MARKED-UP TECHNICAL SPECIFICATION PAGES

## SAFETY EVALUATION FOR THE VIRGIL C. SUMMER NUCLEAR STATION

### DESCRIPTION OF AMENDMENT REQUEST

FIGURE 3.1-3  
 REQUIRED SHUTDOWN MARGIN  
 (MODES 3, 4, AND 5)

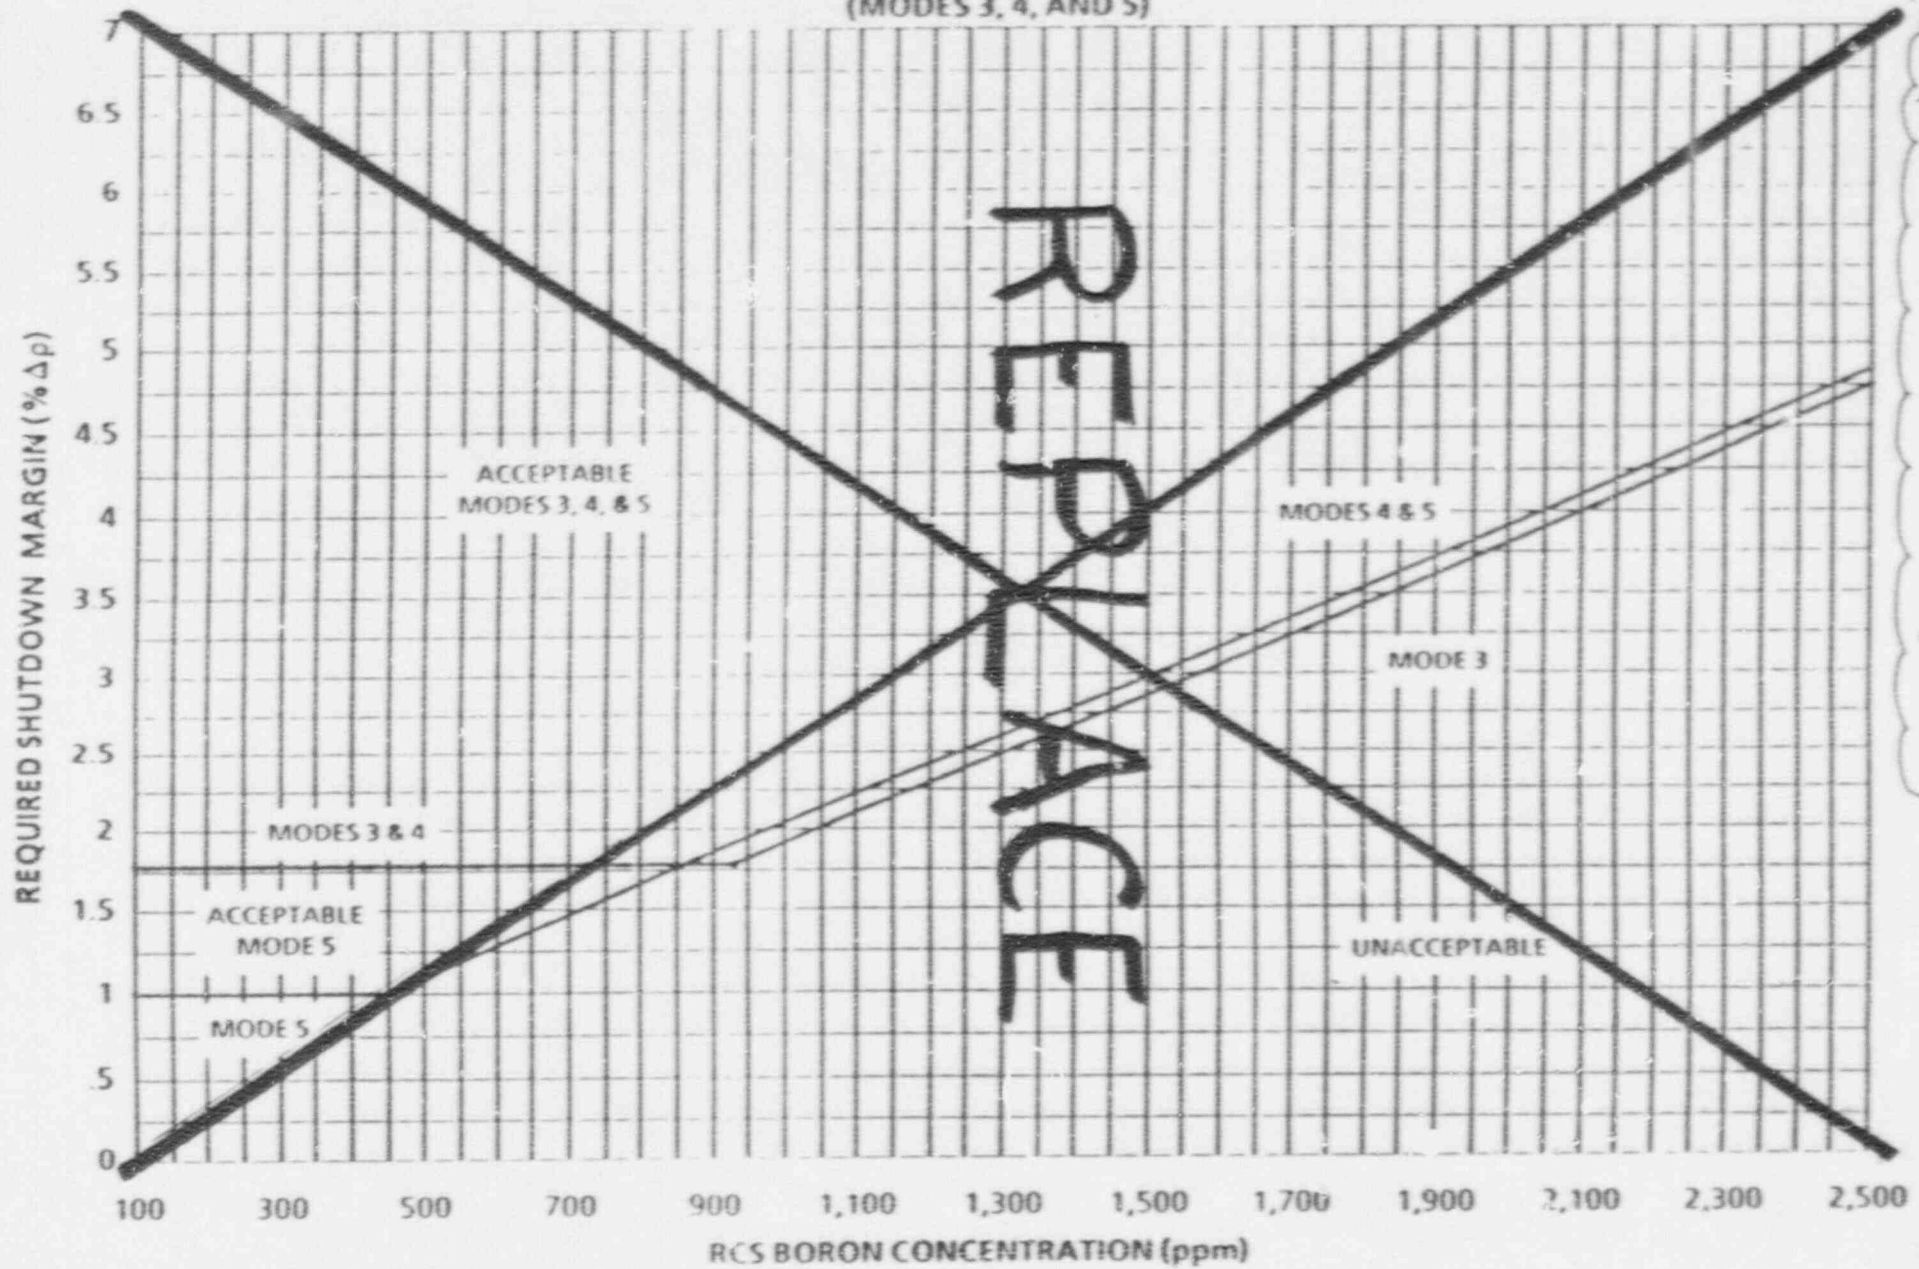
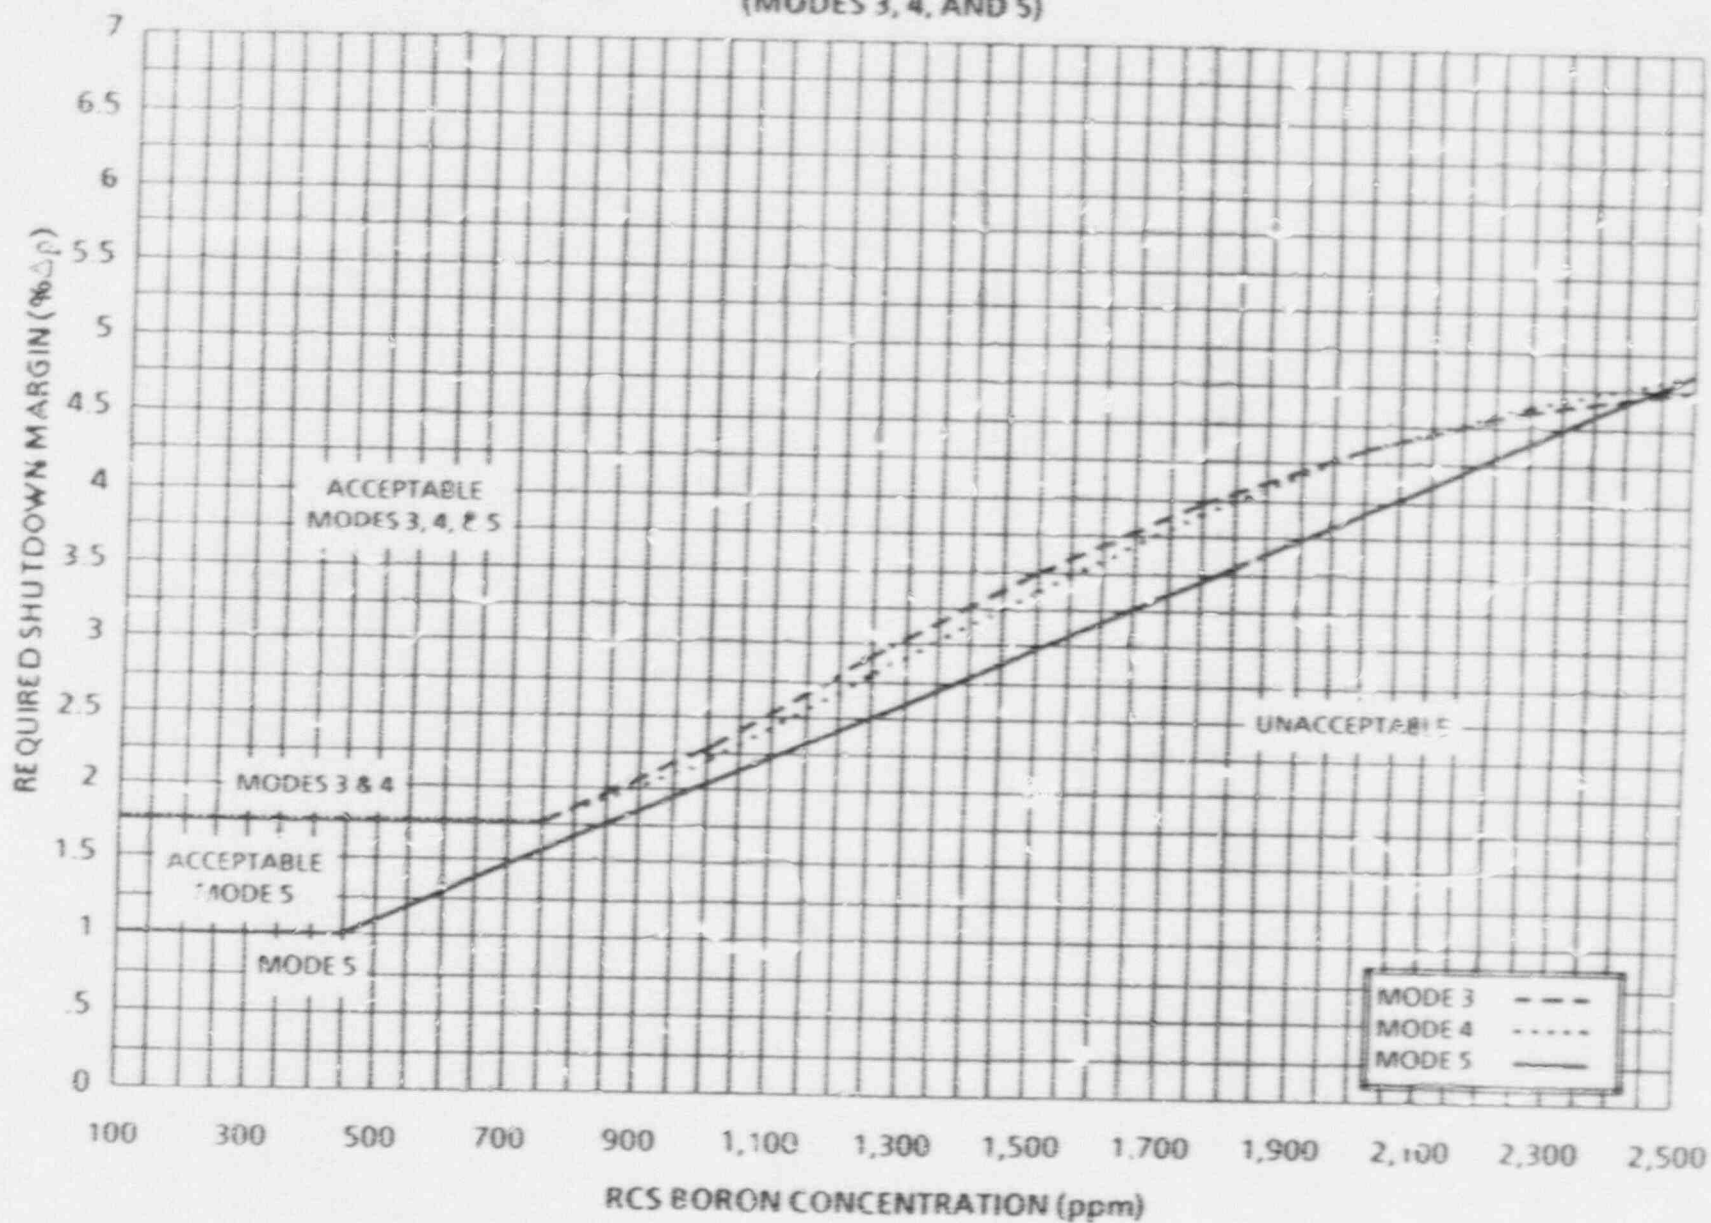
<u>Page</u>	<u>Specification</u>	<u>Change Description</u>
3/4 1-3a	Figure 3.1-3, "Required Shutdown Margin (Modes 3, 4, and 5)"	Revises the Modes 3 and 4 curves in Figure 3.1-3 to incorporate the more negative boron worths associated with the Cycle 6 core and subsequent cores.
B3/4 2-2	Basis 3/4.2.1, "Axial Flux Difference"	Changes "PFLR" to "COLR." Amendment No. 88 (TAC NO. 75049) replaced the PFLR with the COLR.

Replace with Revised Fig. 3.1-3

To resolve this discrepancy, SCE&G proposes to revise the Required Shutdown Margin curve to ensure that the operator action time to detect and terminate an inadvertent boron dilution event is not reduced. The proposed Figure 3.1-3 is provided in Attachment 1. The boron worth for Mode 5 continues to be bounded by previously analyzed values, and, as such, the Mode 5 curve in Attachment 1 is identical to the one currently in the Technical Specifications.

The lines defining the regions of acceptable operation for Modes 3 and 4 in the revised figure exhibit definite curvature, whereas the current Required Shutdown Margin curve consists of straight lines. The method of calculating the data points is identical for both curves. The data for the curve currently in Technical Specifications was bounded by straight lines. To bound the data in the proposed curve would, however, result in requiring prohibitively high shutdown margins for operations at increased boron concentrations. Because of this, the lines defining the regions of acceptable operation for Modes 3 and 4 in the proposed figure reflect the analyses results, and have not been bounded by a linear line.

- ensures that the operator has, at least, the previously accepted 13.4 and 13.6 minutes for Modes 3 and 4, respectively, to recognize and terminate the uncontrolled reactivity insertion associated with a boron dilution before shutdown margin is lost and the reactor becomes critical.
- is based on methods previously reviewed and approved by the Nuclear Regulatory Commission.

PROPOSED REQUIRED SDM CURVE VS. CURRENT TECHNICAL SPECIFICATION REQUIREMENTS SDM CURVE

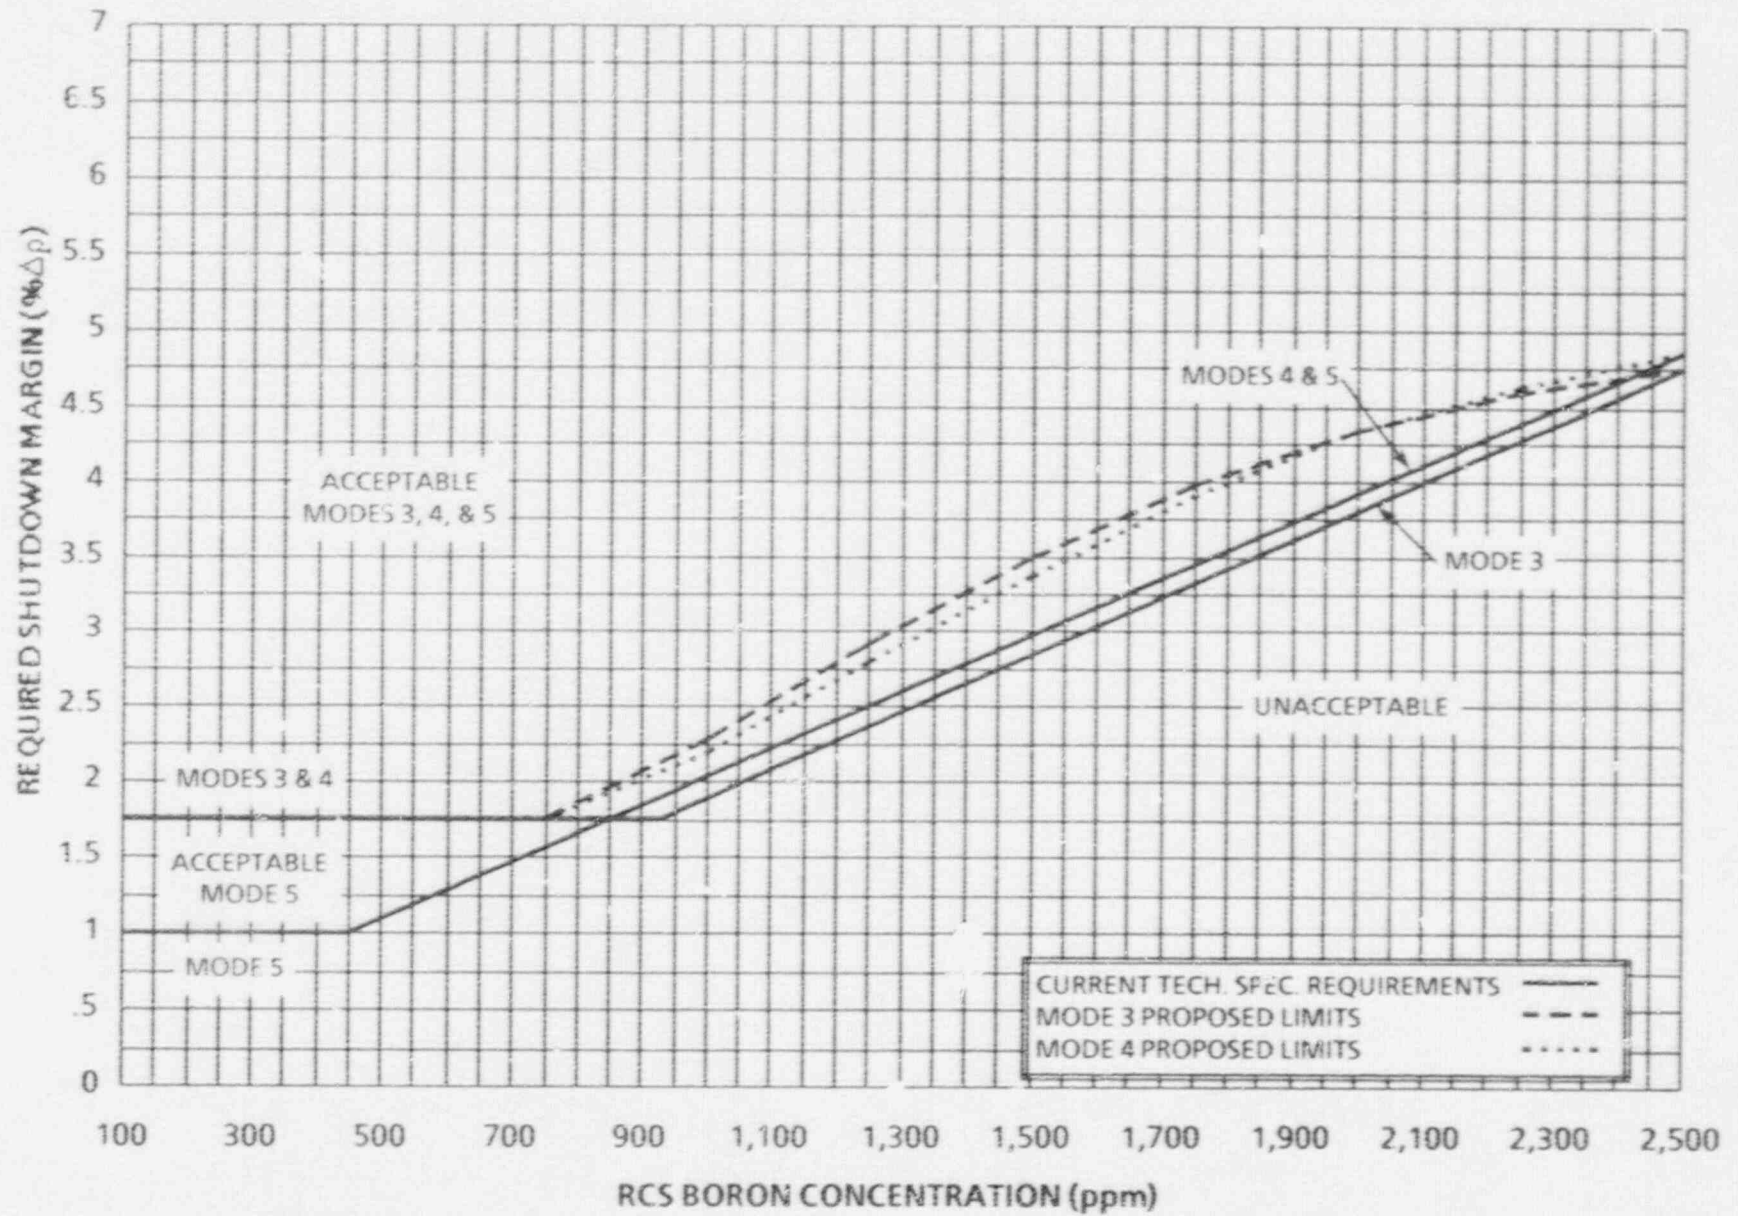
The proposed change to Figure 3.1-3 revises the required shutdown margin as a function of RCS boron concentration for Modes 3 and 4 such that the operator will have at least 13.4 minutes and 13.6 minutes, respectively, from receipt of a high flux at shutdown alarm to recognize and terminate an uncontrolled dilution event before shutdown margin is lost. This will maintain the current margin to criticality, as reflected in the FSAR analysis of the Boron Dilution Event, and thus preserves the margin of safety as defined in the bases for the Shutdown Margin Technical Specification.
